## V2500-A1 SERIES PROPULSION SYSTEMS SERVICE BULLETIN

This document transmits Revision 3 to Service Bulletin V2500-ENG-72-0027

# V2500-ENG-72-0027

ENGINE - HIGH PRESSURE COMPRESSOR - INTRODUCTION OF REDUCED WEIGHT FRONT COMPRESSOR  
CASING

View showing radial position of additional borescope access hole at stage 3  
Figure 2

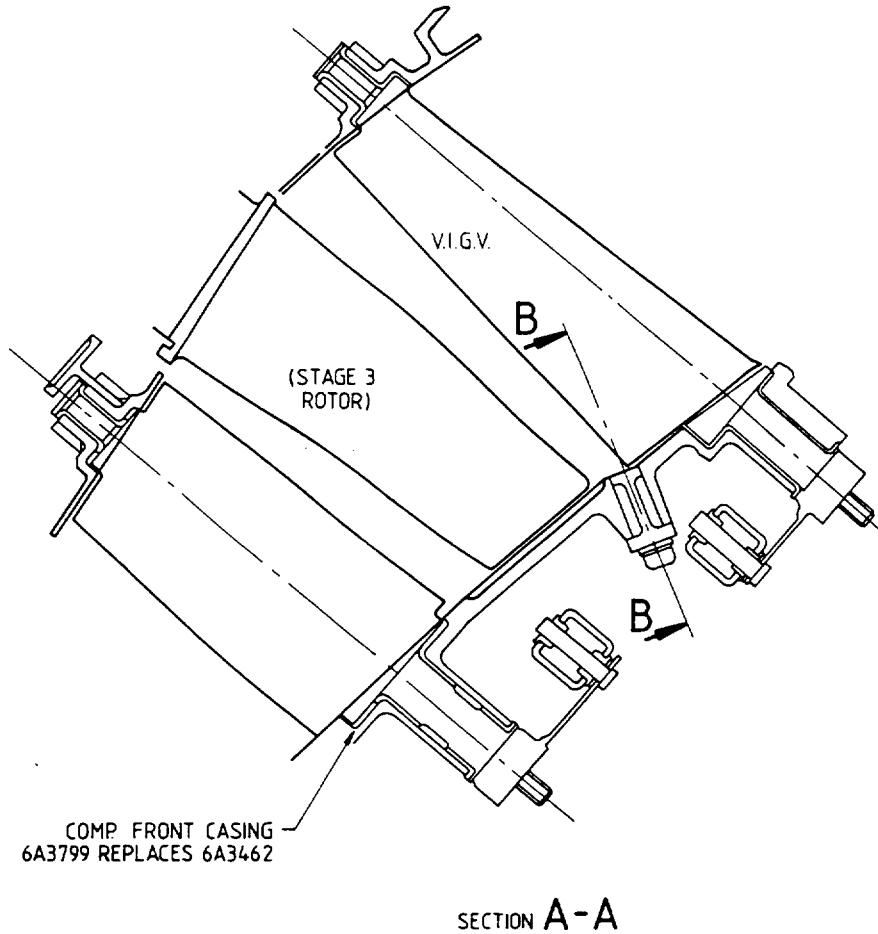
- (b) An additional borescope point in front of the stage 3 rotors at 40.9 degrees below the LH split line which allows greater inspection capability.

View showing section A-A (see Figure 2) and section B-B  
Figure 3

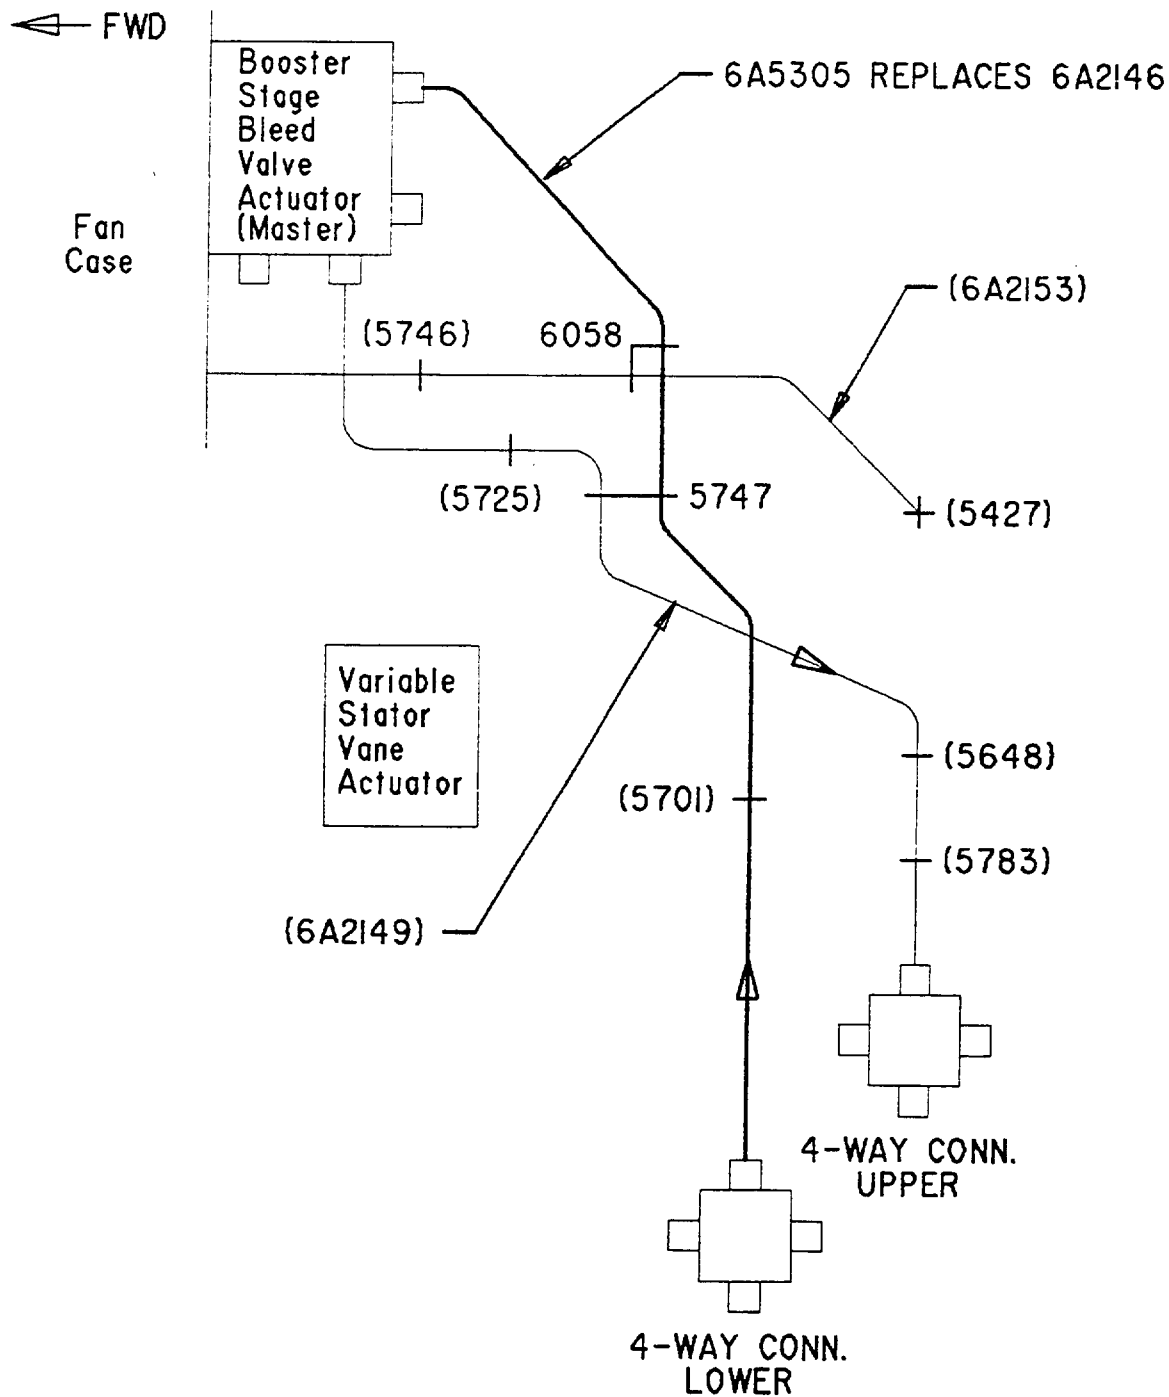
- (2) Revisions to the borescope ports.
    - (a) Circumferential relocation of the stage 5/6 borescope access from 66.7 degrees below the RH split line to 33.5 degrees below the LH split line and the blanking plug is now a two-piece arrangement. New stage 6 rotor path segments are necessary with the repositioned borescope.

Clipping Point 5747 -  
Before and after alteration  
Figure 5

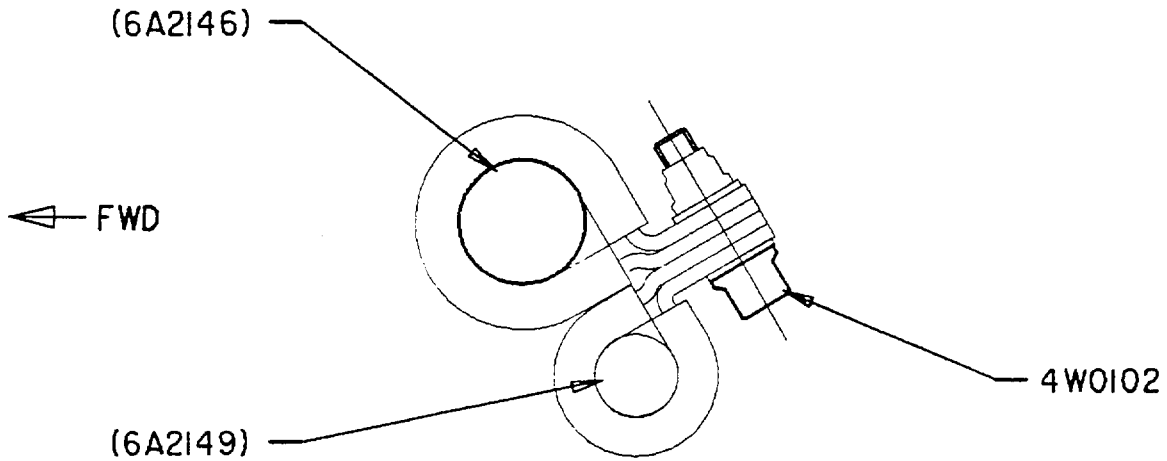
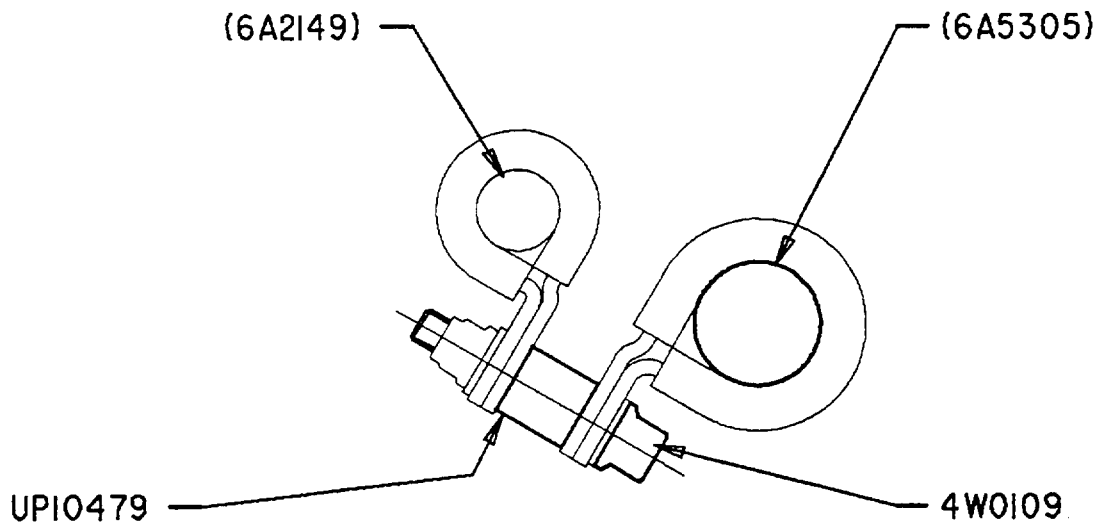
- R (d) To avoid a foul between the new connector assemblies at the engine LH side, a new fuel servo tube, from the 4 way connector to the LPC bleed master actuator, is required, which is routed over instead of under raceway 6A2153. Minor changes to the two existing Clipping Points 5747 and 6058 are made to suit the revised routing.
